# STAFF REPORT

SUBJECT: H-2024-0060  
Lennon Pointe – PP, PS

### I. PROJECT DESCRIPTION

### A. Preliminary Plat (dated: 10/25/24)

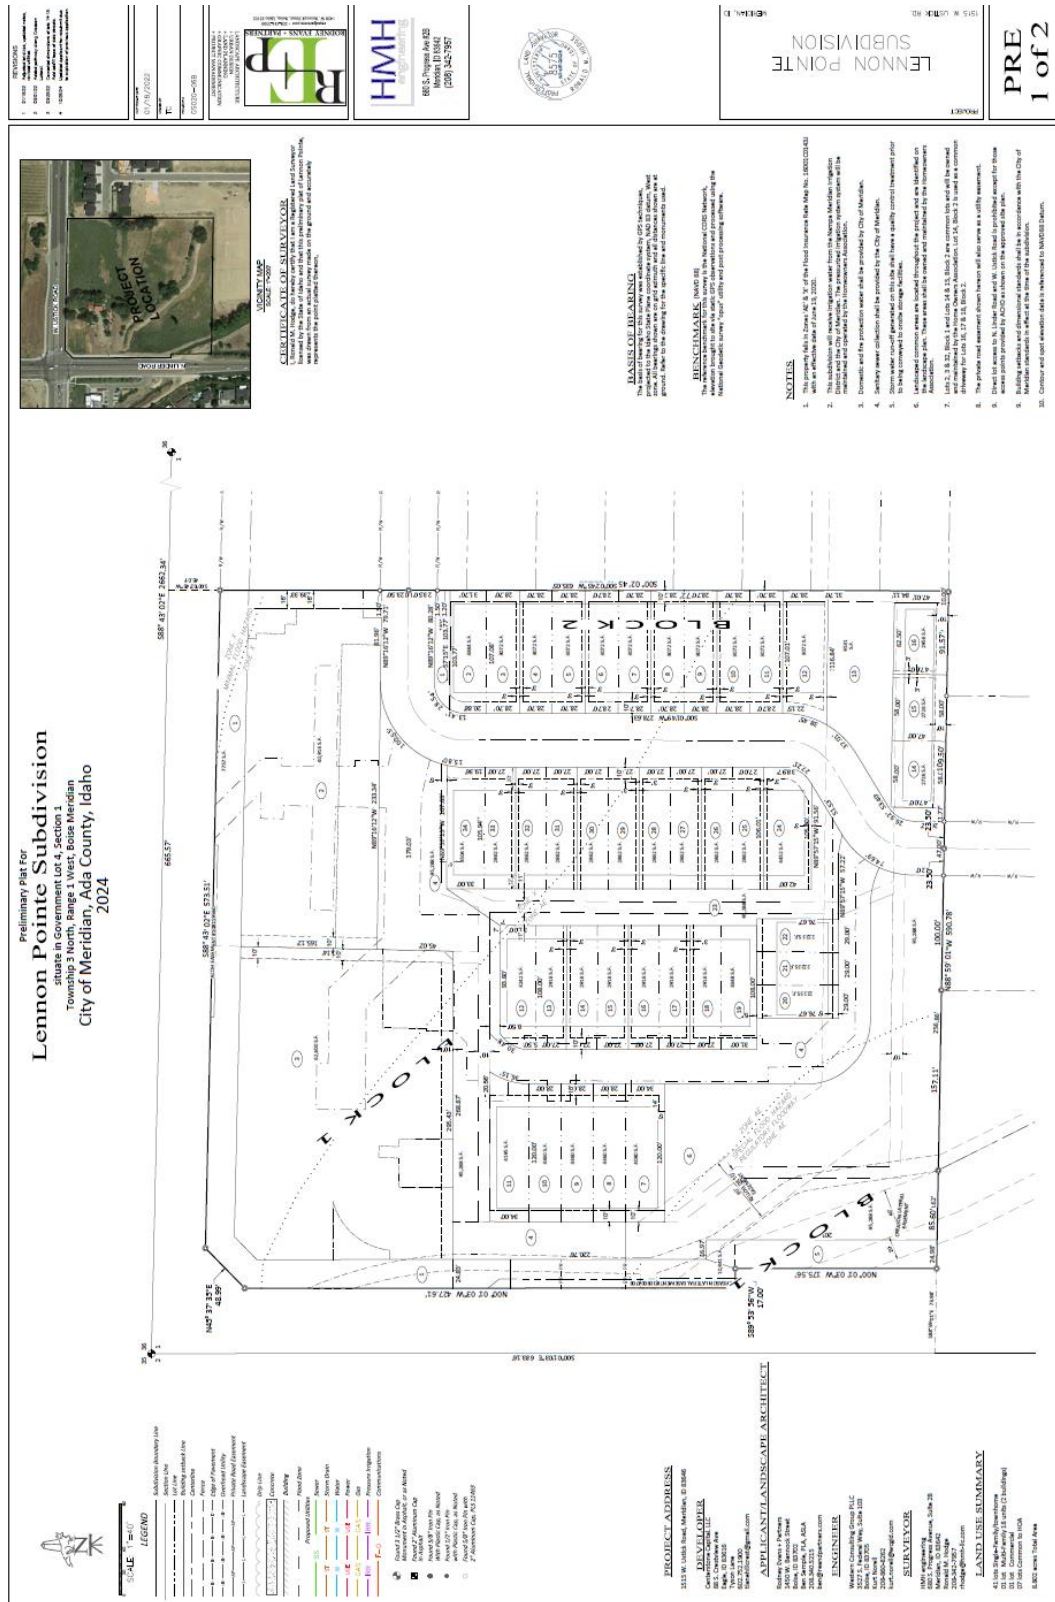
2. The final plat shall include the following revisions:
  - a. Widen Lots 14-16, Block 2 to accommodate the minimum front setback of 20-feet to the face of garage on these lots.

- b. Depict a minimum 20-foot wide perpetual ingress/egress easement on Lot 13 for the common driveway and include a note for the easement requiring maintenance of a paved surface capable of supporting fire vehicles and equipment in accord with UDC 11-6C-3D.8. Alternatively, a separate 20-foot wide common lot could be included for the common driveway.

- c. Plat note #7 includes incorrect common lot numbers; revise accordingly and remove the portion pertaining to the common driveway.
  - d. Depict a 26-foot wide easement for the private street on Lot 4, Block 1 and include a note granting an ingress/egress/cross-access easement to all lots in the subdivision to use the private streets on Lot 4, Block 1.

- g. The private street shall be a loop off the local street (i.e. N. Zion Park Ave./W. Pebblestone Dr.) and shall not extend to the west of N.W. 15th Ln. along the north side of Lot 11, Block 1; the private street shall terminate on the west side of N.W. 15<sup>th</sup> Ln.

- h. Depict an access easement for the driveway proposed via N. Linder Rd. to the commercial property on Lot 3, Block 1 and for the driveway along the north side of Lot 11, Block 1 between the townhomes and commercial lot; the easements should grant access to all lots within the subdivision.

- j. Depict an ingress-egress easement across Lots 2 and 3, Block 1 granting access to all lots in the subdivision.
3. The landscape plan, included in Section VII.D, shall be revised as follows prior to submittal of the Final Plat application:

# C. Common Driveway Exhibit

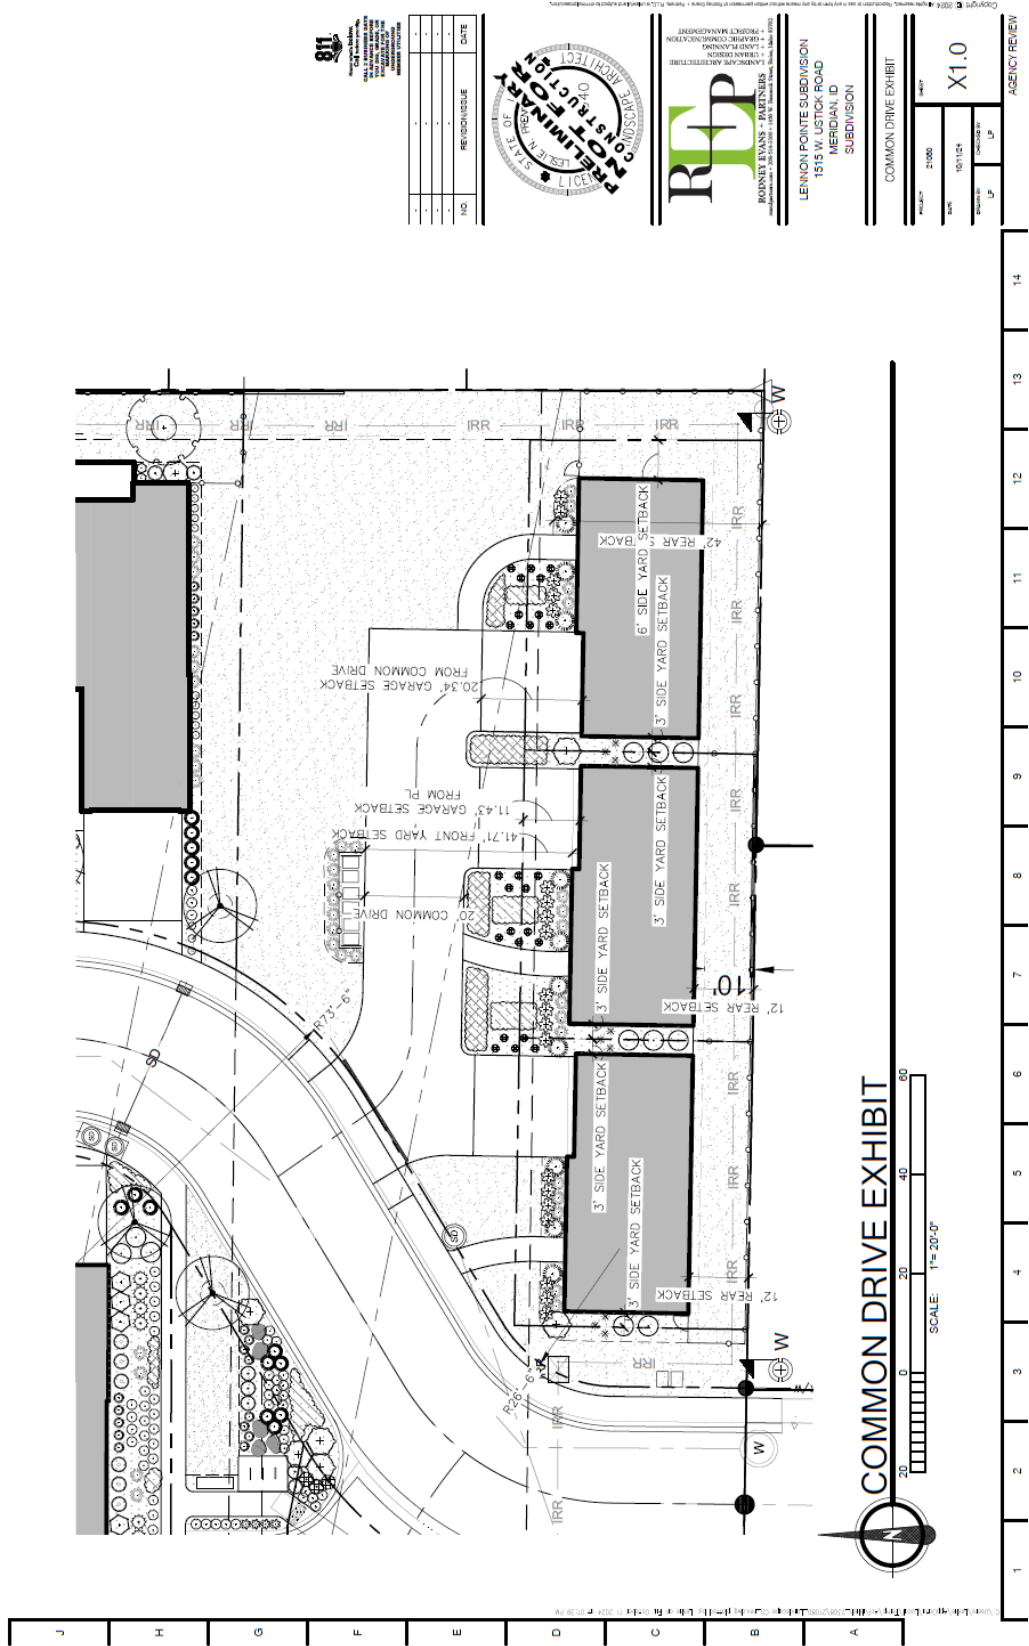
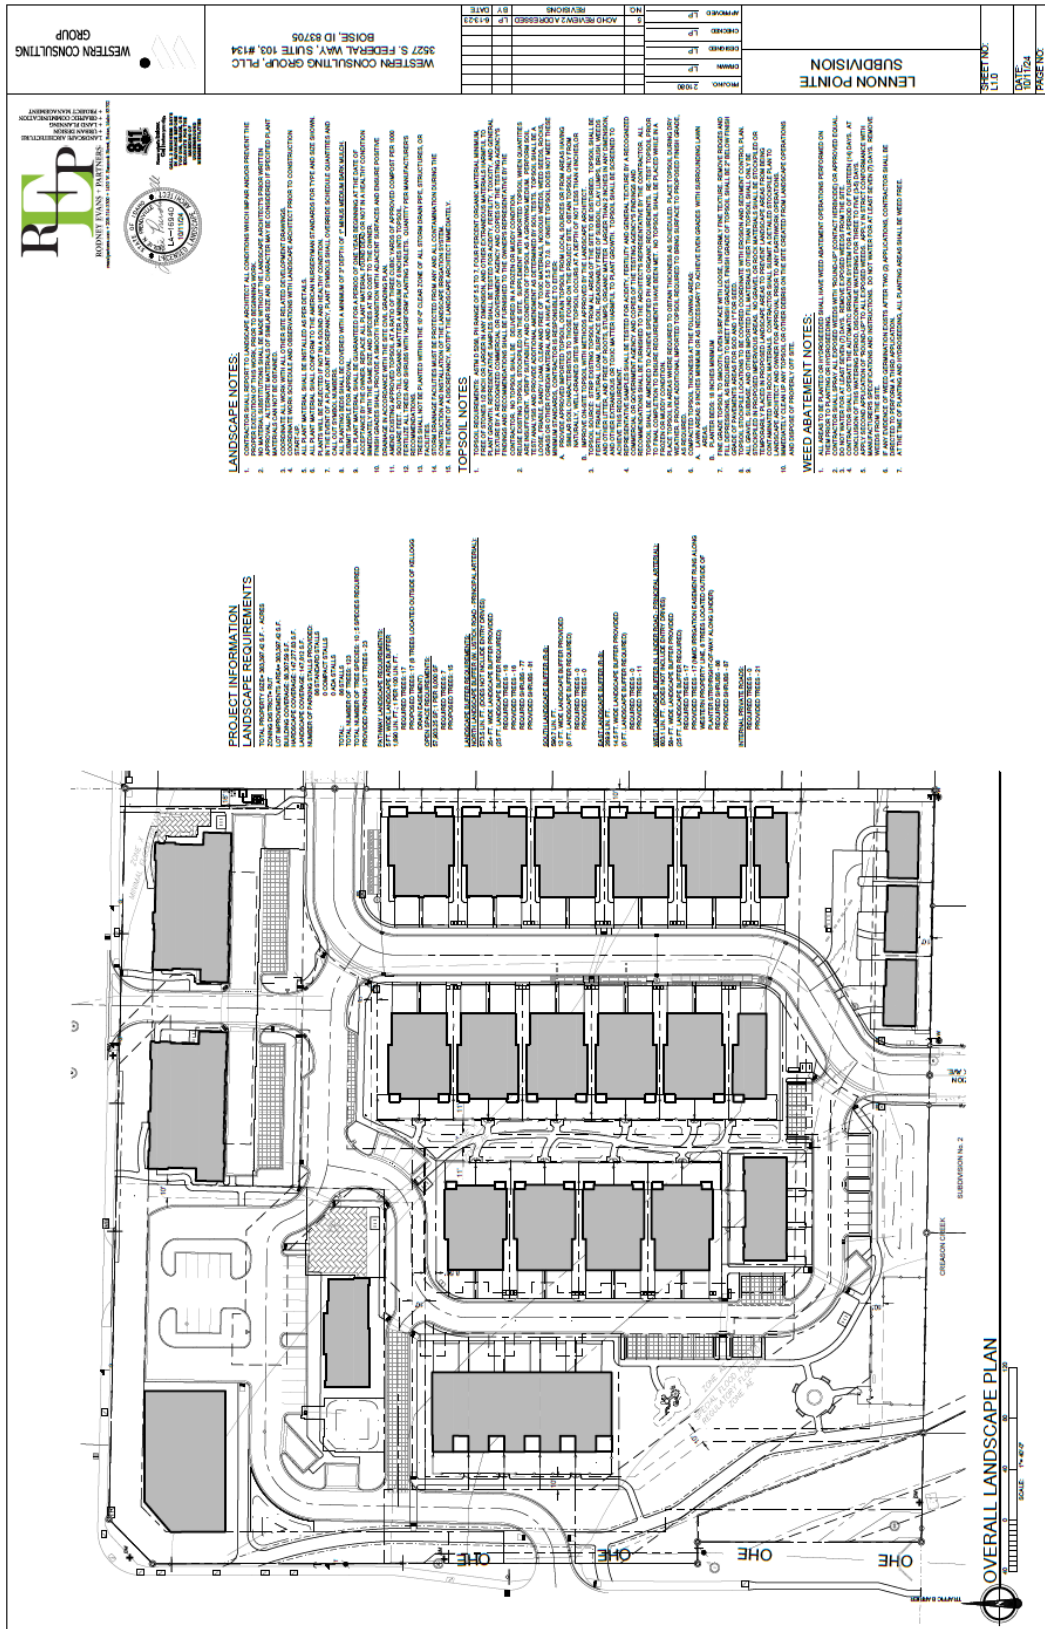
A common driveway is proposed on Lot 13 off N. Zion Park Ave., a local street, for access to the single-family homes proposed on Lots 14-16, Block 2 at the southeast corner of the site as shown in the exhibit in Section VII.C below. The driveway complies with the standards for such listed in UDC 11-6C-3D pertaining to maximum number of dwelling units to be served by the driveway and the number of units located on one side of the driveway, and the minimum width and maximum length standards. The exhibit depicts the proposed building envelopes with building setbacks – the side, rear and front setback to living area comply with the standards but the front setback to garage is below the minimum 20-foot standard – a portion of the 20-feet is depicted on the adjacent common lot where the common driveway is located. **The plat should be revised to reflect wider building lots to accommodate the front setback to garage on the building lot so that parking pads in front of garages are on privately owned lots rather than common lots. A minimum 20-foot wide perpetual ingress/egress easement should also be depicted on Lot 13 for the common driveway (or the driveway may be placed in a separate common lot), and a plat note should be included for the easement, which requires maintenance of a paved surface capable of supporting fire vehicles and equipment.**

7. A revised common driveway exhibit shall be submitted with the final plat application that reflects the revisions to the plat noted above.
  8. A floodplain development permit shall be required prior to any site work occurring on the property.
